Improved Technical Specifications

LaSalle County Station

Volume 8:
Section 3.7

ComEd

FIGURE 4.7-1
SAMPLING PLAN FOR SNUBBER FUNCTIONAL TEST

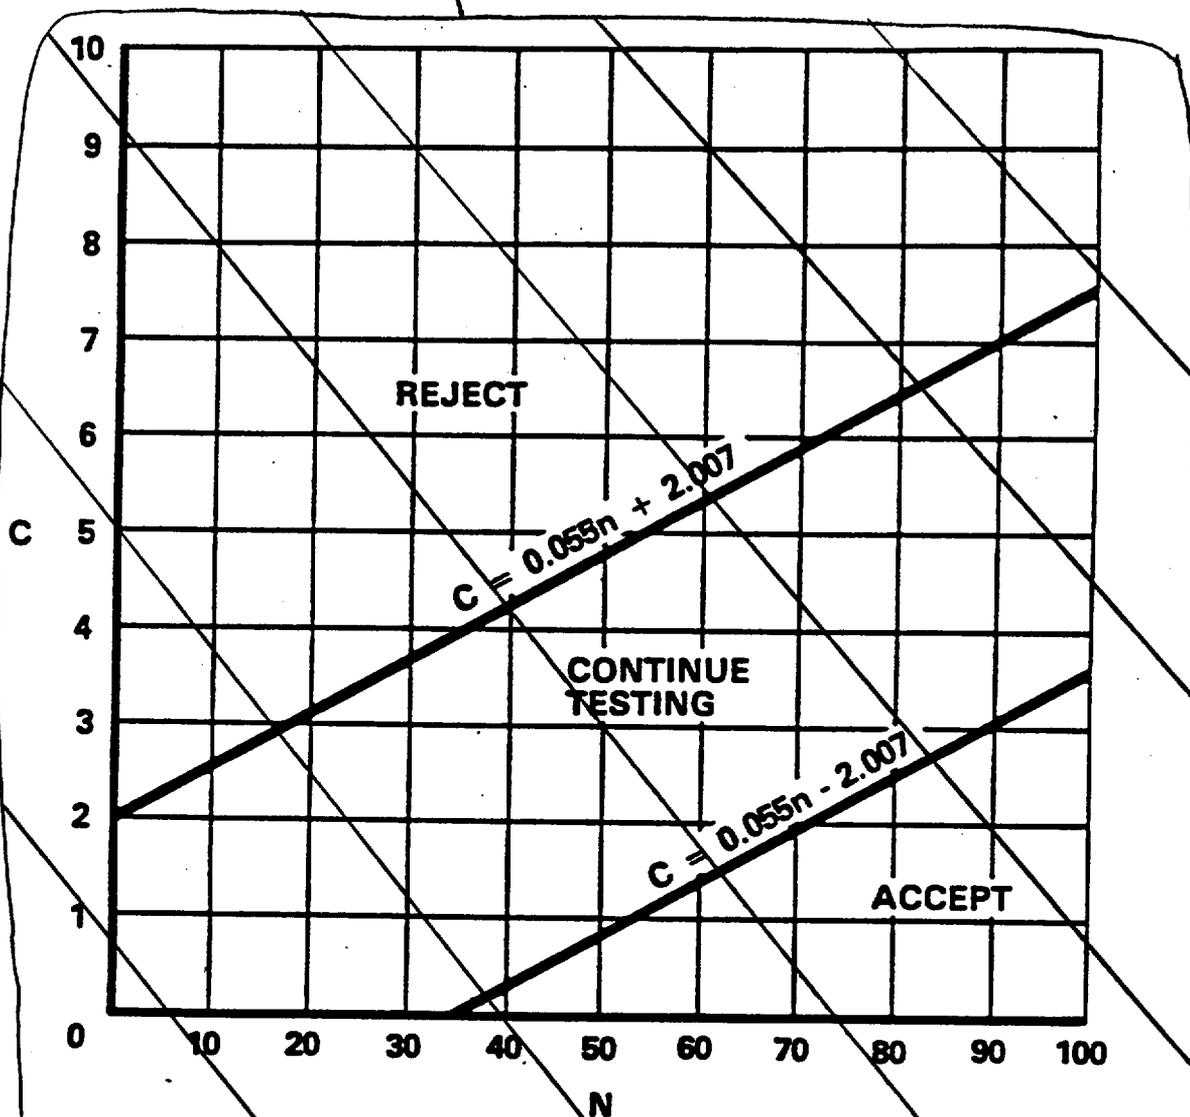
CTS 3/4.7.9

LA11

FIGURE 4.7-1

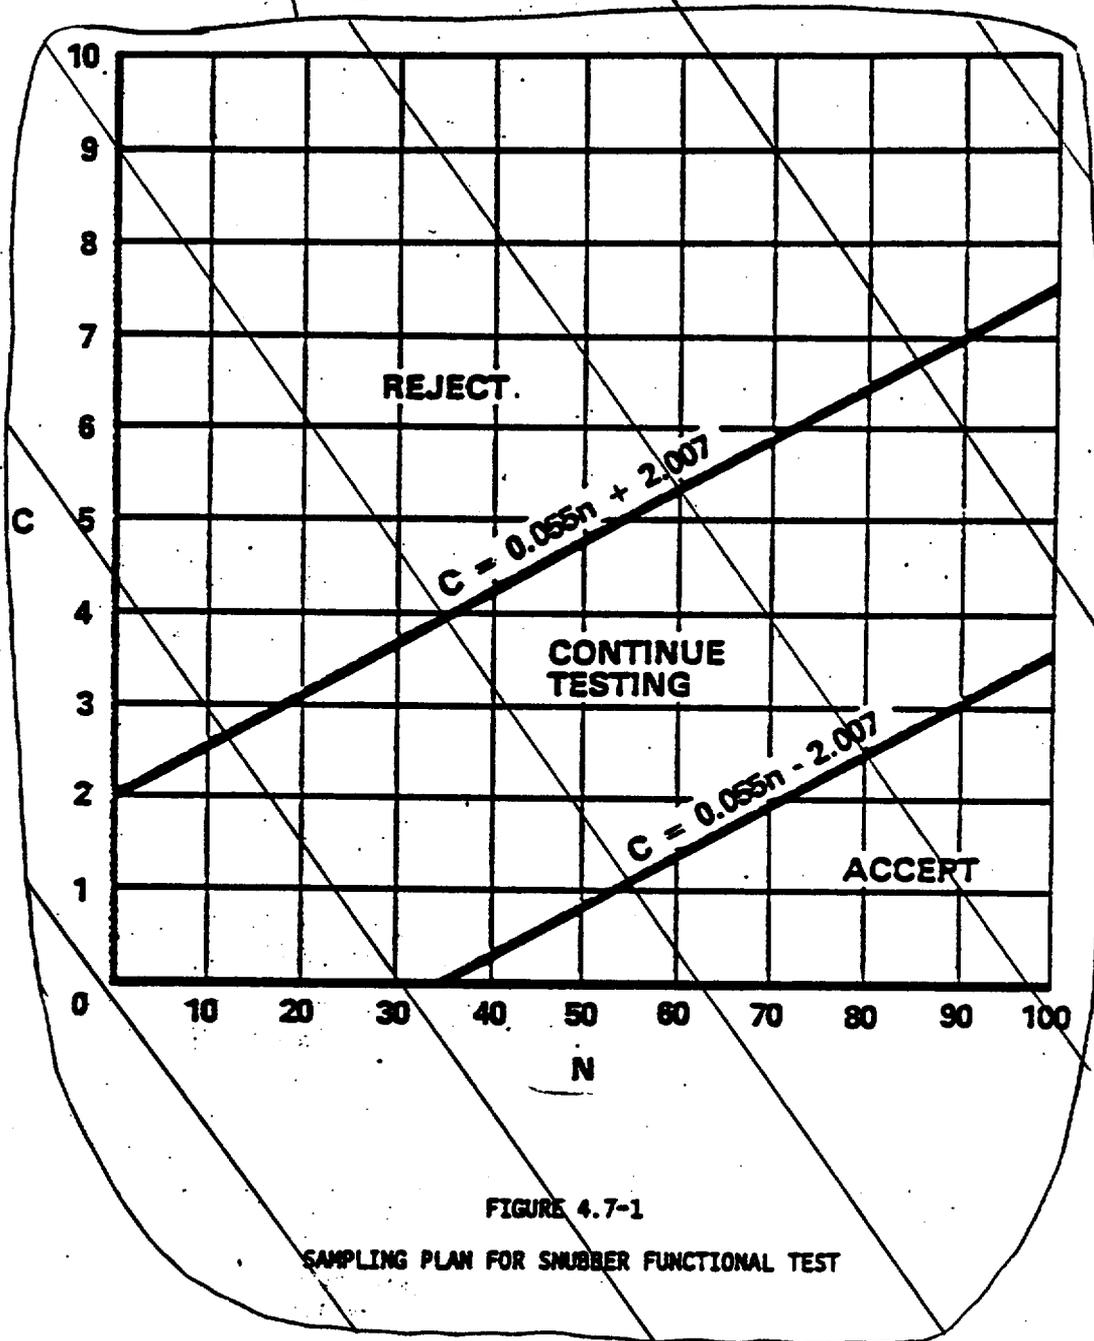
CTS 3/4.7.9

LA.11
